Local Planning Panel

Address: 98-106 Kippax Street, Surry Hills

Application: D/2025/758

Substantial demolition of the existing building and construction of an 8-storey mixed-use development with retail tenancies on the lower levels, basement carparking, residential apartments and associated landscaping.

Building components: Footprint of 1904 stable—red box, 1880s building—green box, 1913 building—blue box, 1930s building—black box;

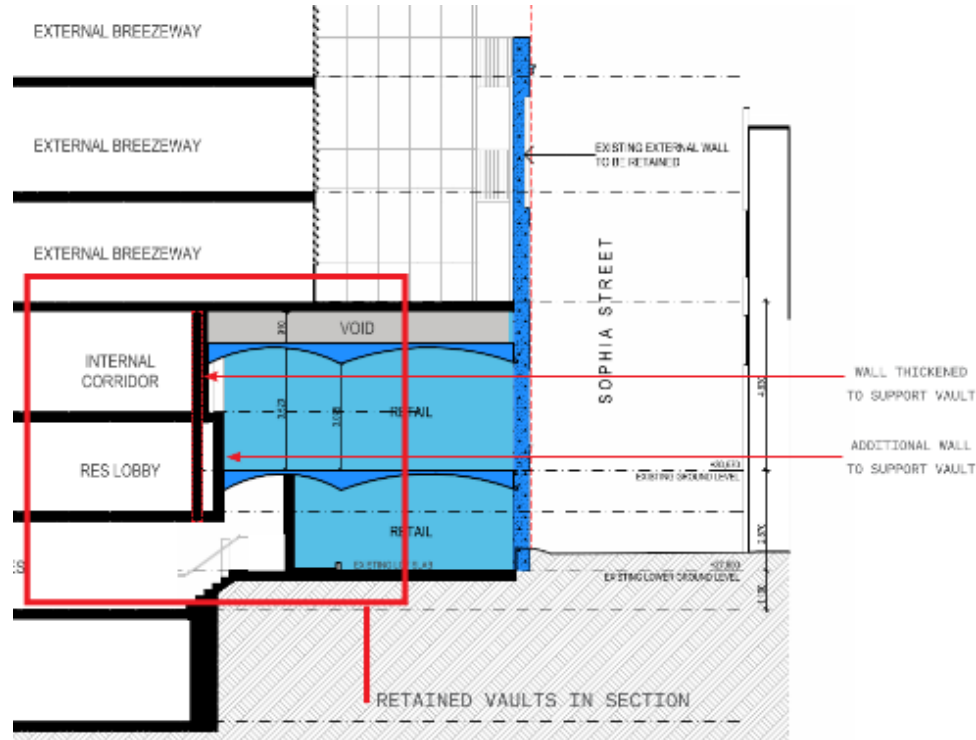
- no heritage listings, although the former Schwepps Stables is significant
- proposal retains the external walls, floors and vaults of the former Schweppes stables
- original horse ramp retained and expressed

Retention of significant fabric

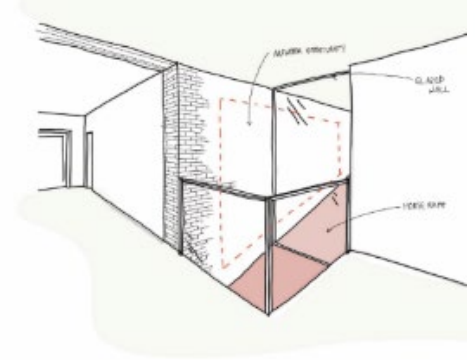
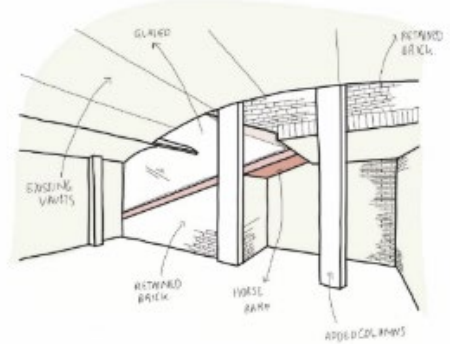
1. Horse ramp frames lobby wall which is used to display art.

2. Geometry of the horse ramp is exposed whilst partial elements of existing wall are retained as columns.

Cross ventilation

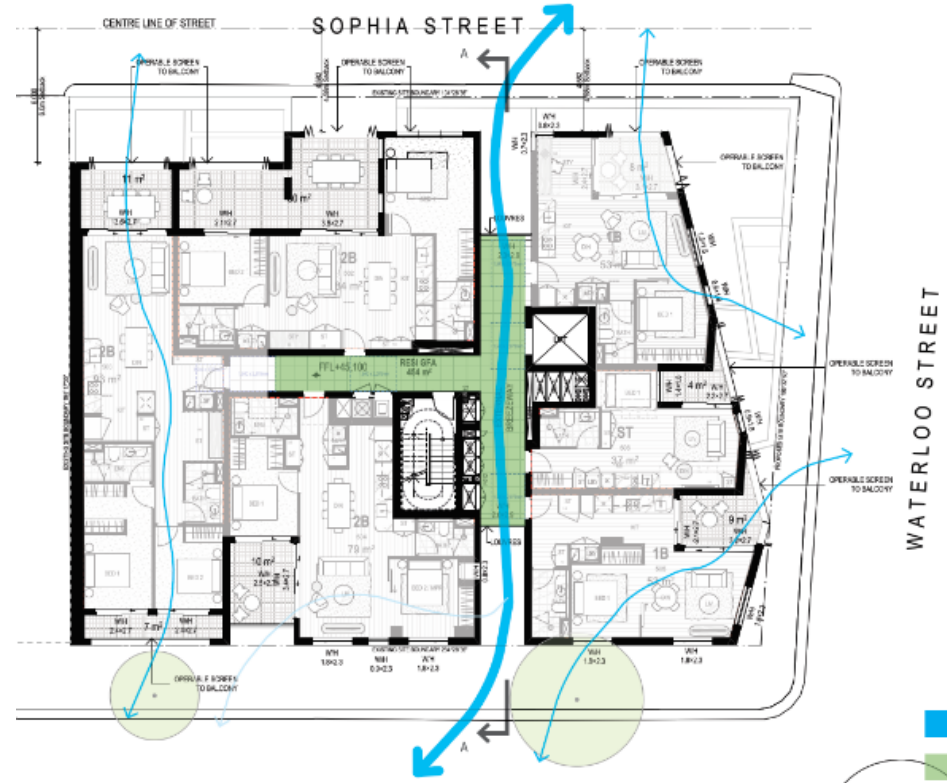
- ADG requires 60% of apartments to be cross-ventilated
- 50% (21 units) able to be naturally cross-ventilated
- north-south breezeway provided as resiliency measure for additional natural ventilation

- breezeway allows 62% (26 units) apartments to be cross-ventilated
- achieves objectives of ADG to maximise cross-ventilation to create a comfortable indoor environment for residents

Cross ventilation

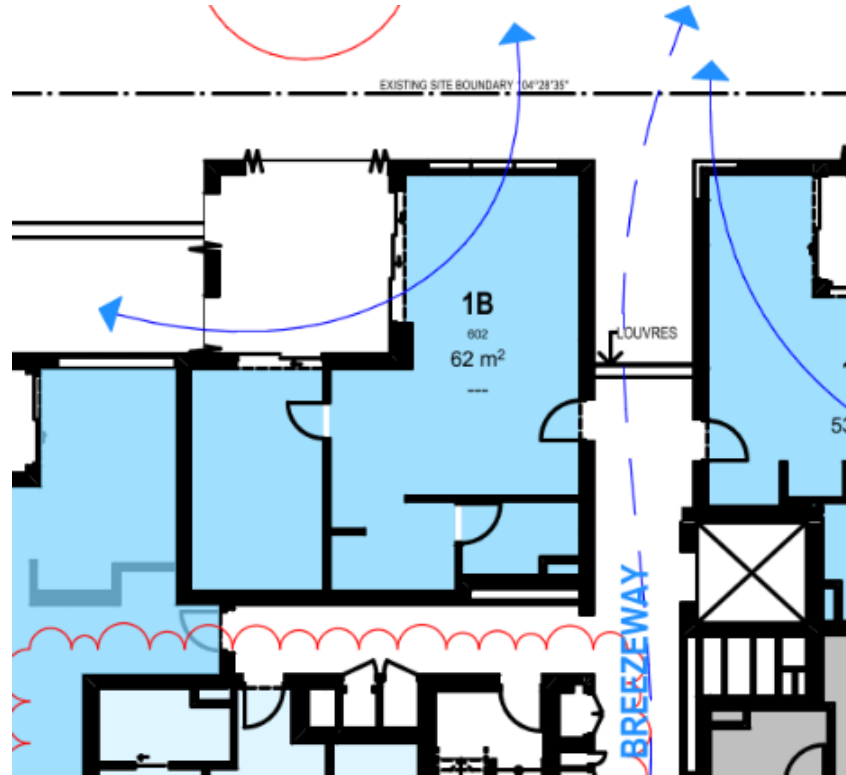
- north facing unit 602 not strictly cross-ventilated
- consent condition recommended to incorporate operable fanlight above the entrance door to provide additional cross-ventilation

Building separation

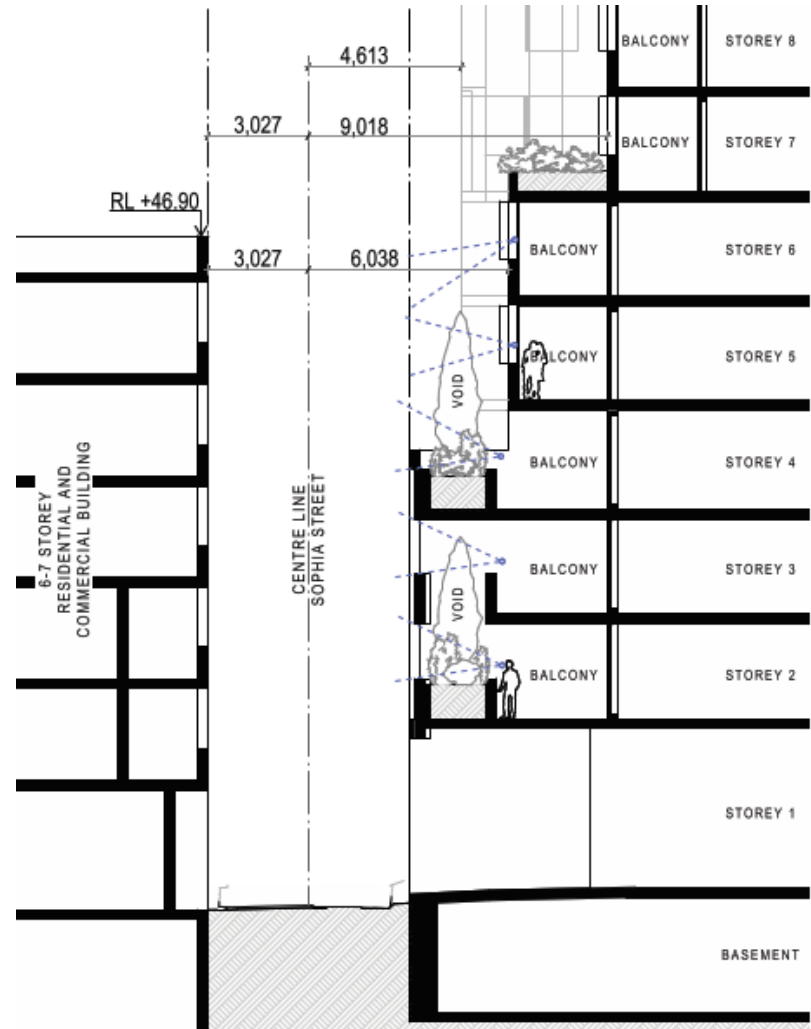
- non-compliance with ADG minimum separation distances to Sophia Street
- ADG requires 9-18m separation distances for up to eight storeys
- 6-9m separation provided to apartments and commercial buildings on opposite side of Sophia Street
- proposal incorporates operable privacy screens and staggered setbacks to address visual privacy

Entrance awning

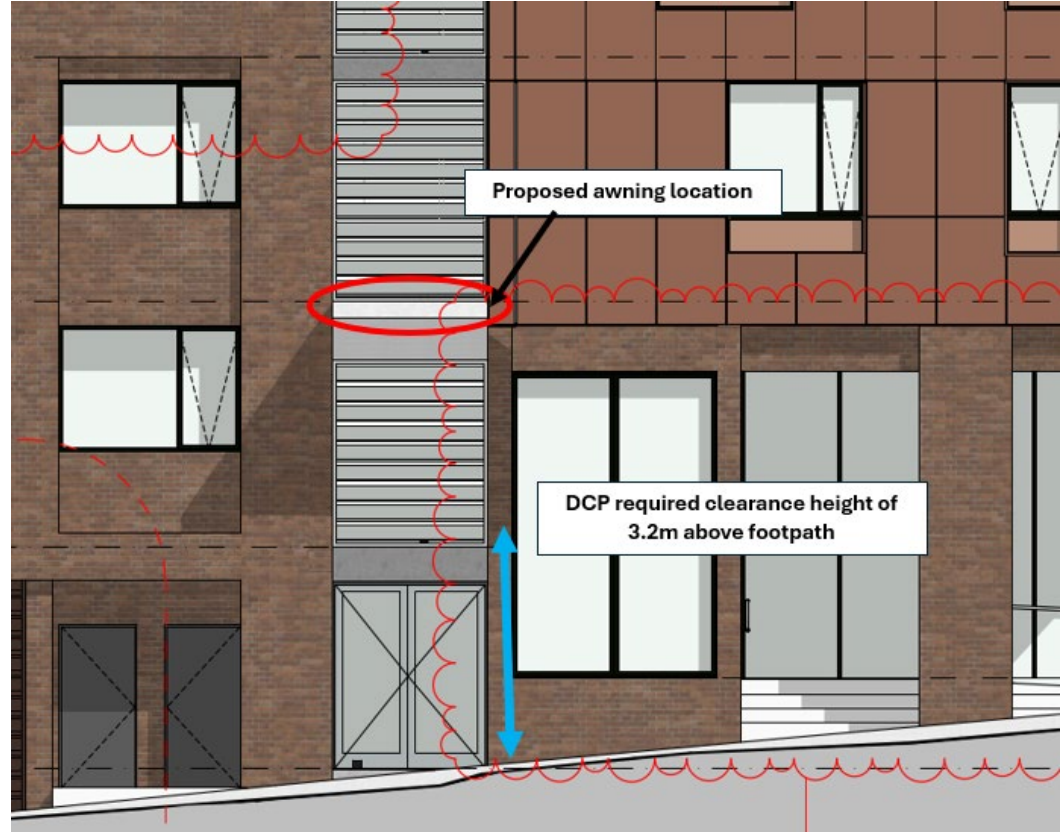
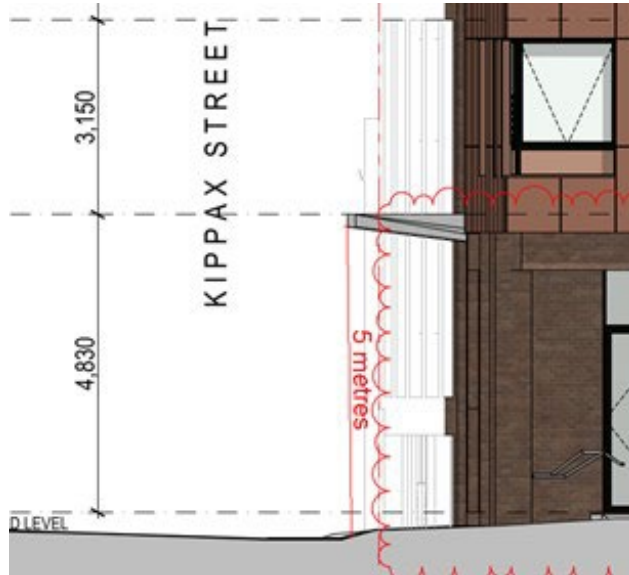
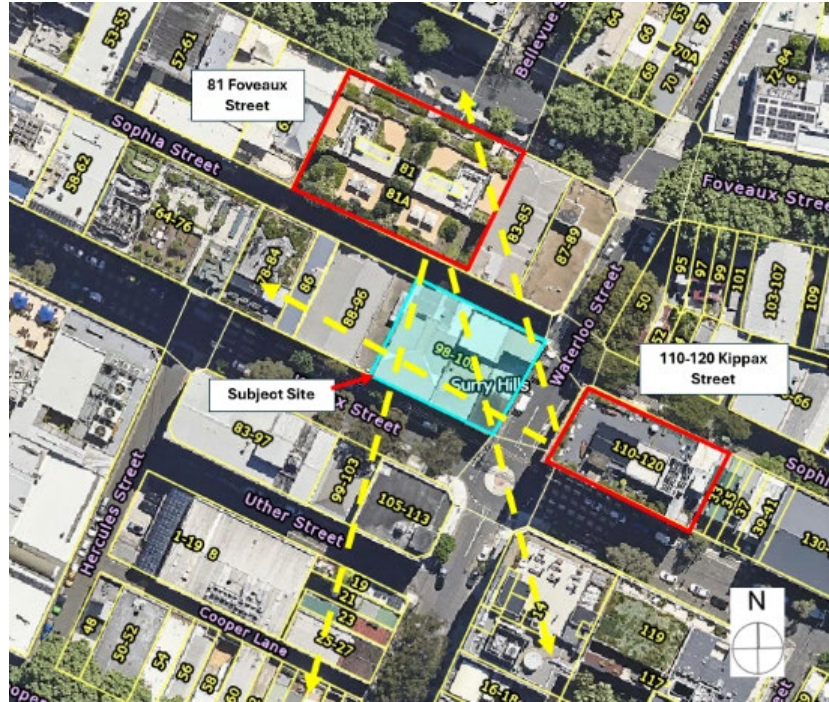
- awning too high above entrance to provide weather protection
- lowering awning would require significant pruning of the street tree

- incorporate operable fanlight above the entrance door of Unit 602
- provide additional 11 bike spaces at lower ground floor level
- delete entrance awning to Kippax Street
- provide physical materials and samples board
